MANDATORY SERVICE

PACSB / XL / 093 ISSUE 1

COCKPIT CONTROL HANDLES

(Refer to Figure 1)

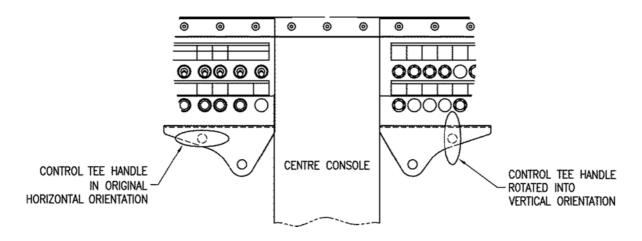
- A. <u>EFFECTIVITY</u> PAL 750XL aircraft up to and including S/N 0215.
- B. <u>REASON</u> During a ground inspection, it has been observed that it was possible for the Control Column to snag on the Cockpit Control Tee handles which are mounted below the Switch Panels adjacent to the Centre Console. Snagging might occur with the Control Column in the full forward and inboard position. Depending on the specific configuration of the aircraft, this could affect the Heater, Ventilation or Engine Air Filter Bypass Tee handles.

Reorient Control Tee Handles which are found to snag the Control Column.

- 1) Rotate the Control Handle into a vertical orientation as applicable (Figure 1).
- 2) If there is sufficient thread allowance on the Control Cable Shaft, rotate the Tee Handle 90° clockwise into a vertical orientation by tightening the Handle further onto the shaft.
- 3) If there is not enough thread travel to rotate the Control Handle 90^o clockwise, remove the handle by rotating anticlockwise. Depending upon the condition of the thread in the Tee Handle:
 - a) Install a Check Nut P/N AN315-4R onto the Control Cable Shaft or;
 - b) Apply Threadlocker (Loctite 243) to the thread.
- 4) Reinstall the Control Handle so it is oriented vertically (Figure 1). Ensure the handle does not rotate freely on its thread.
- 5) Repeat for the Control Handles on both sides of the Centre Control Console as appropriate.
